9.3 Process Auxiliaries

The information in this section of the reference ABWR DCD, including all subsections, tables, and figures, is incorporated by reference with the following departures and supplements.

Figure 9.3-10 Breathing Air System Flow Diagram

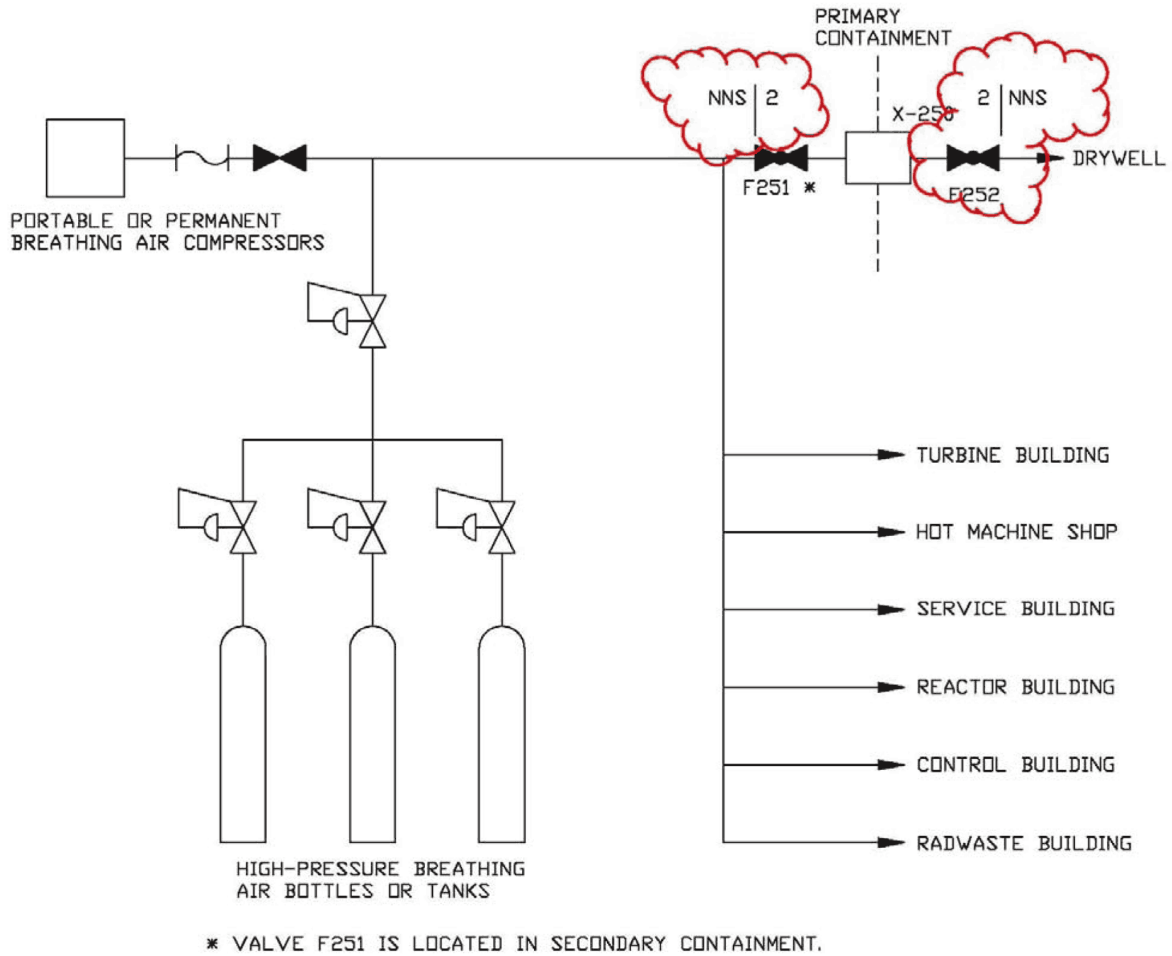
The BAS is sized to provide 100% of the peak air consumption using the bottled breathing air supply and a portable permanent breathing air compressor supply system, as needed. The compressor(s) will be of the oil-less, breathing air type.

The BAS flow diagram is shown in Figure 9.3-10.

The BAS containment and penetration and associated isolation valves are designed to Seismic Category I, ASME Code, Section III, Class 2, Quality Group B and Quality Assurance B requirements.

The bottled breathing air supply and a portable or permanent breathing air compressor supply system, as needed, are operated during normal operation.

Outside and inside primary containment manually-operated valves are kept closed and locked during normal plant operation. During refueling, the valves are opened to provide air inside the containment. This arrangement meets GDC 56, Option (1).

Figure 9.3-12 Non-Radioactive Drainage System

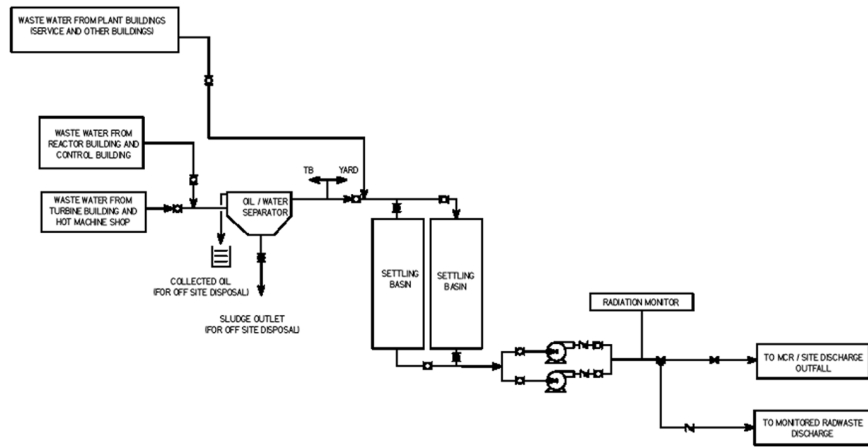
The design of the continuation of the non-radioactive drain system from the ABWR Standard Plant Buildings to the site discharge outfall is provided in Figure 9.3-12 and is discussed in this subsection.

The non-radioactive drain system collects waste water from plant buildings (Reactor, Turbine, Control, Service, and other buildings). A system composed of collection piping, curbs, and pumps is provided. Non-radioactive waste water from the Turbine Building, Reactor Building, hot machine shop and the Control Building is routed to a dedicated oil/water separator where oil and settled solids are removed for off-site disposal. The non-oily, non-radioactive effluent is sent to dual settling basins. Non-radioactive waste water from the Service Building and other buildings is sent directly to the dual settling basins. Means are provided to perform any required tests or

analyses required by the discharge permit. The non-radioactive liquid effluent is discharged to the Main Cooling Reservoir through permitted outfall(s). If radioactivity levels exceed the limits for discharge, the flow from the non-radioactive drains has the capability to be diverted to the radioactive effluent portion of the radwaste system. Normally, if low levels of radioactivity are detected, it is quantified and discharged via the normal outfall. Higher levels of radioactivity may require a permitted "batch" discharge via the radwaste effluent radiation monitor. The non-radioactive drainage system is illustrated in Figure 9.3-12.
